Hope Creek Generating Station  
Facility Operating License No. NPF-57  
NRC Docket No. 50-354

Subject: Relief Request for Third Interval Inservice Inspection Program for  
Examinations and Tests of Snubbers and Associated License Amendment  
Request

**Relief Request HC-I3R-04**

**Relocation of Technical Specification 3/4.7.5 and Addition of  
LCO 3.0.8 Regarding Snubbers**

Figure 4.7.5-1

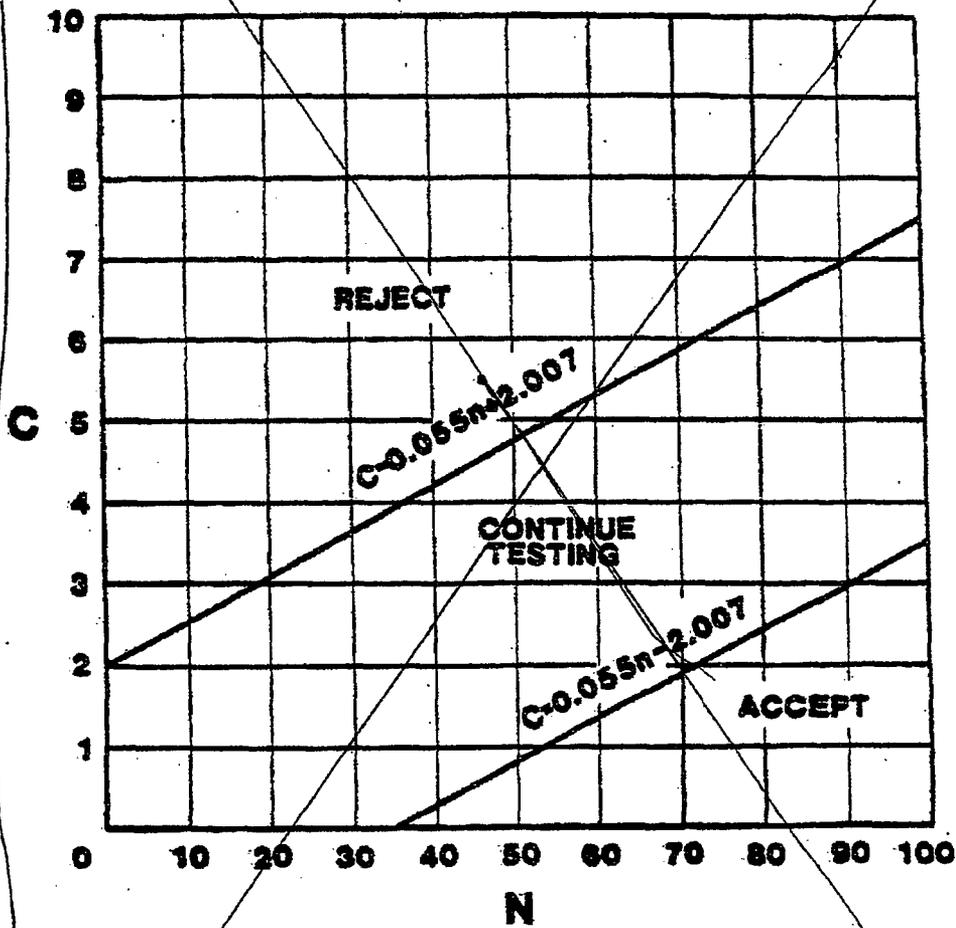
**Subject: Relocation of Technical Specification 3/4.7.5 and Addition of LCO 3.0.8  
Regarding Snubbers**

TS 3/4.7.5, "Snubbers," would be removed from the TS and relocated to the HCGS TRM. In addition, TS 6.10.3.1 which refers to Technical Specification 4.7.5, would be removed from the TS and relocated to the TRM.

The proposed change would remove TS 3/4.7.5, "Snubbers," from the TS and relocate it to the HCGS TRM. As discussed below, the snubber TS requirements do not meet any of the four criteria in 10 CFR 50.36(d)(2)(ii) for inclusion in the TS.
